COTTAGE GROVE CITY COUNCIL

STAFF REPORT CASE: SP2024-023

REQUEST: A site plan review application for two additions to Park High School and additional site improvements on the Park High School and Crestview Elementary School sites.

**Planning Staff Report
Park High School
Planning Case No. SP2024-010
November 25, 2024**

Sheet C200:

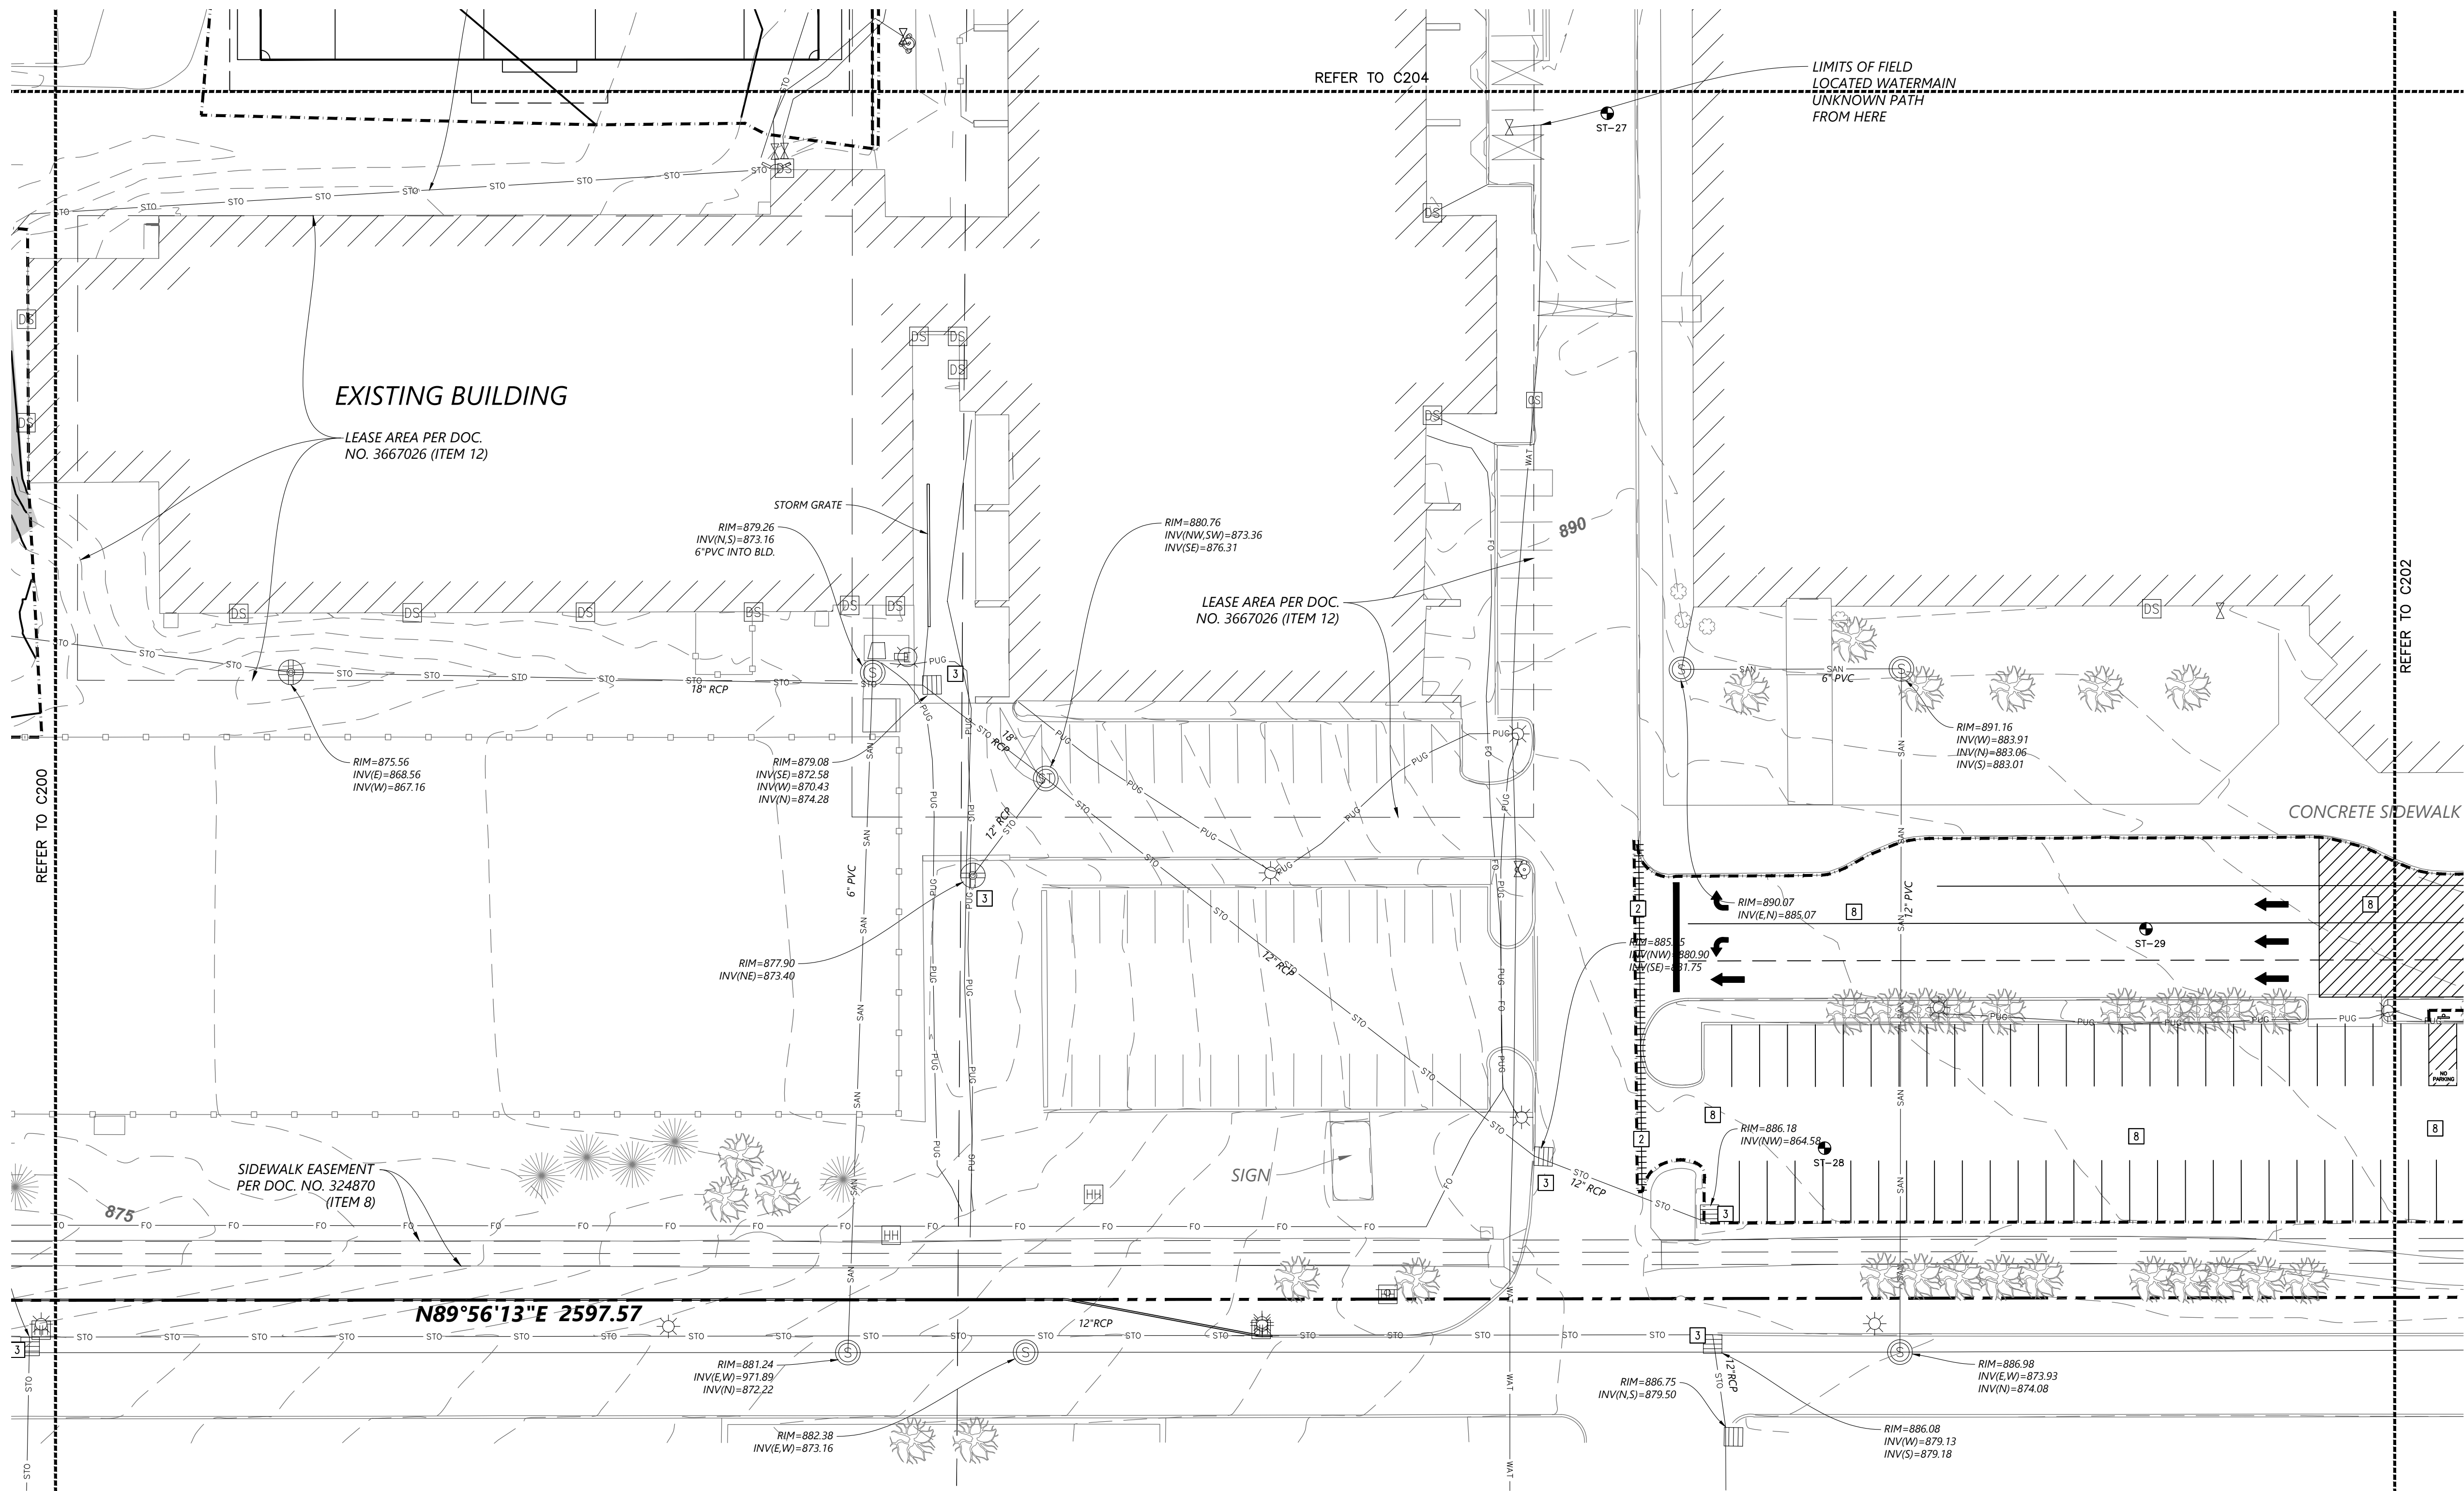
20. SWPPP:
 - a. Sheet C200 states that: "Approximate disturbed area is 19.00 acres." Please include a tabulation of disturbed area, existing and proposed impervious surfaces, fully reconstructed impervious surfaces and milled/overlaid surfaces.

Sheet C205:

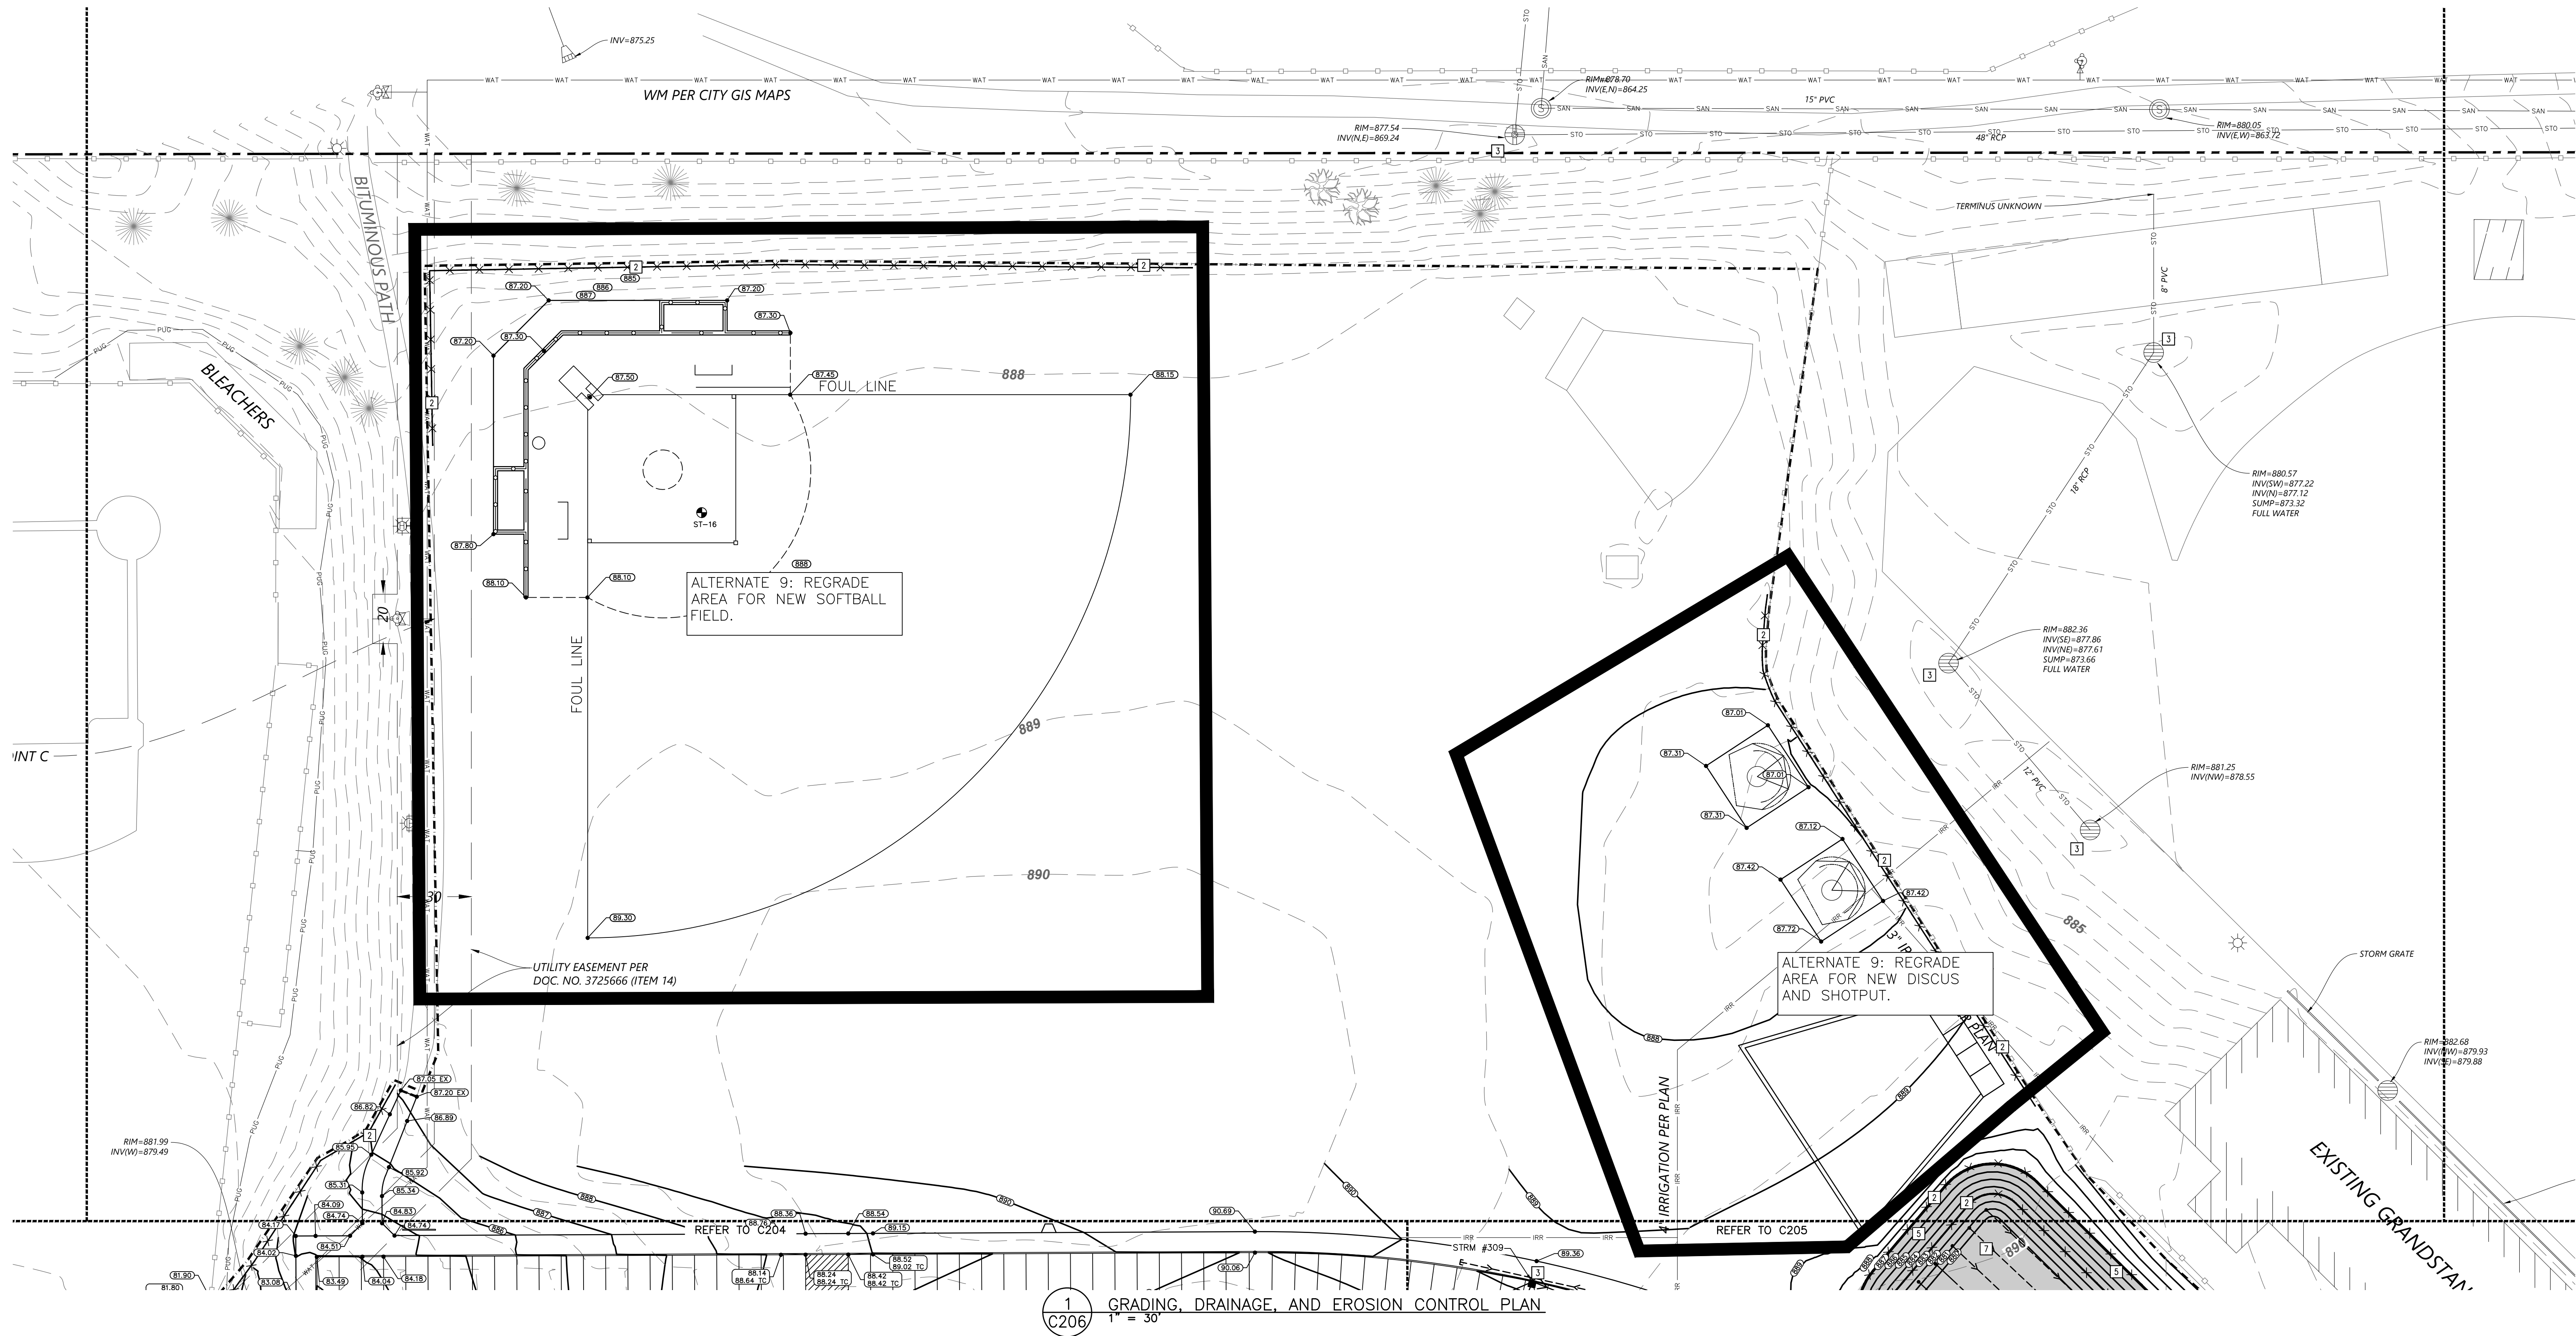
8. The new apron on Ideal Avenue should depict a mill-overlay per city detail STR-21. An exception to the mill overlay was provided on 80th Street since it's planned to be rehabilitated in 2026, but that does not apply to Ideal Avenue.

- a. Sheet C205 lists the HWL of Filtration Basin 2 as 888.28 feet. Please revise the HWL elevation to match the HydroCAD model (887.16 feet).
 - b. It appears freeboard requirements are met on the site. For clarity, please label the location and elevation of the emergency overflows (EOFs) for each stormwater basin.

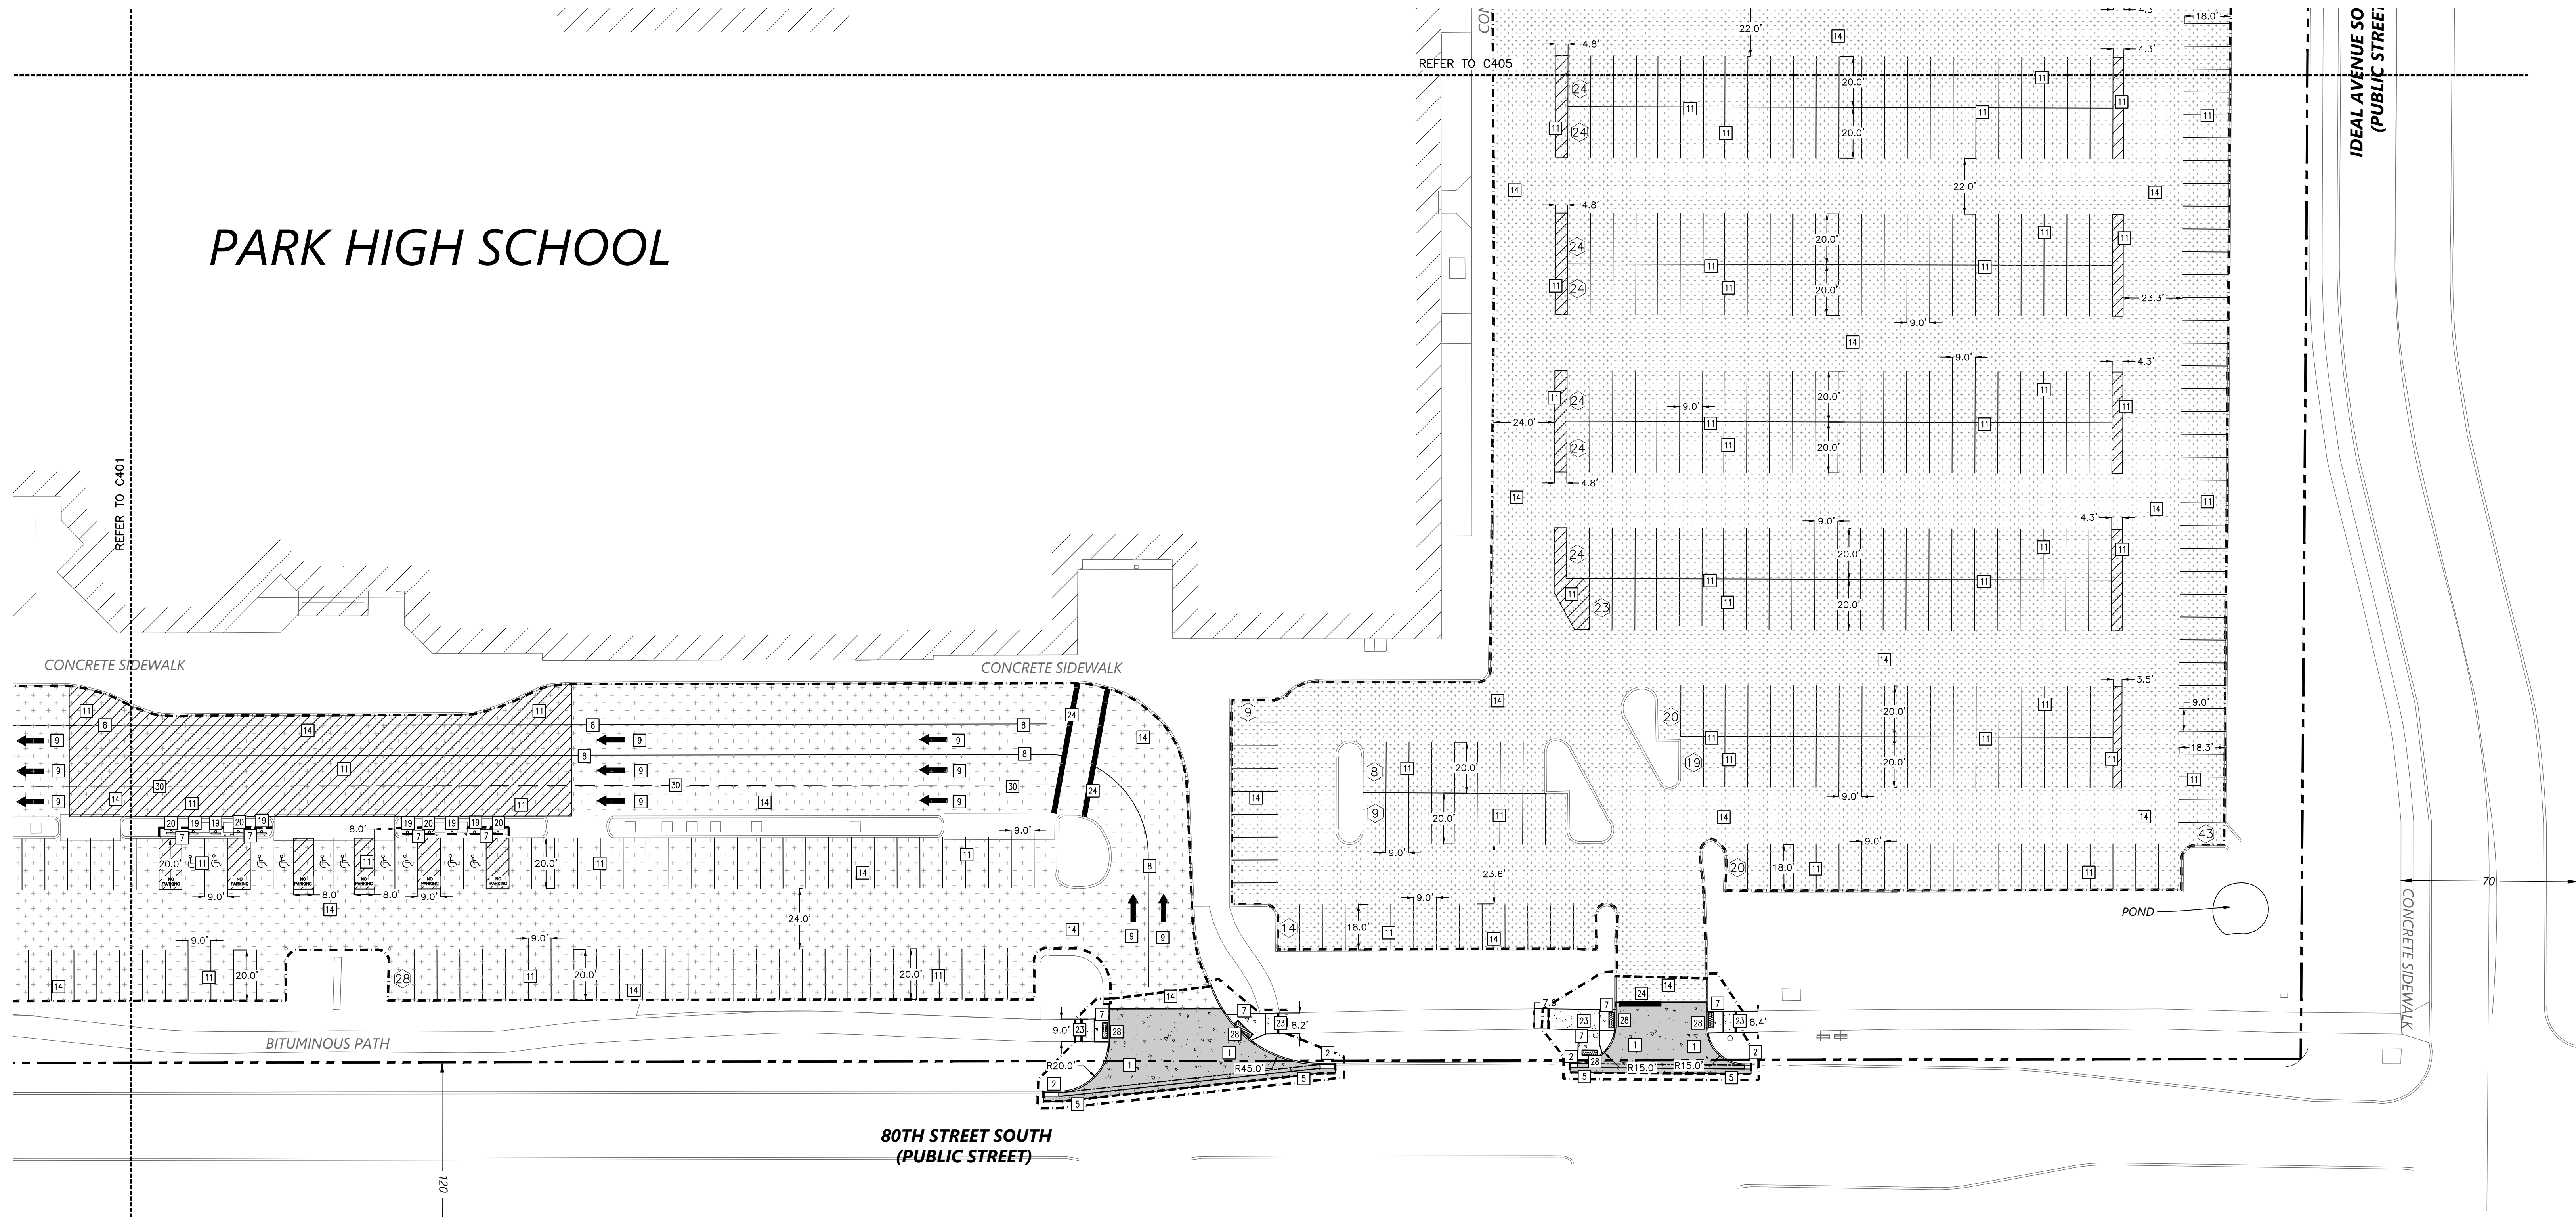
- a. On Sheet C400 the right-in does not depict the existing curb line. Depending on when this is intended to be constructed, additional detail should be provided as to how it fits into the existing roadway in an interim condition.
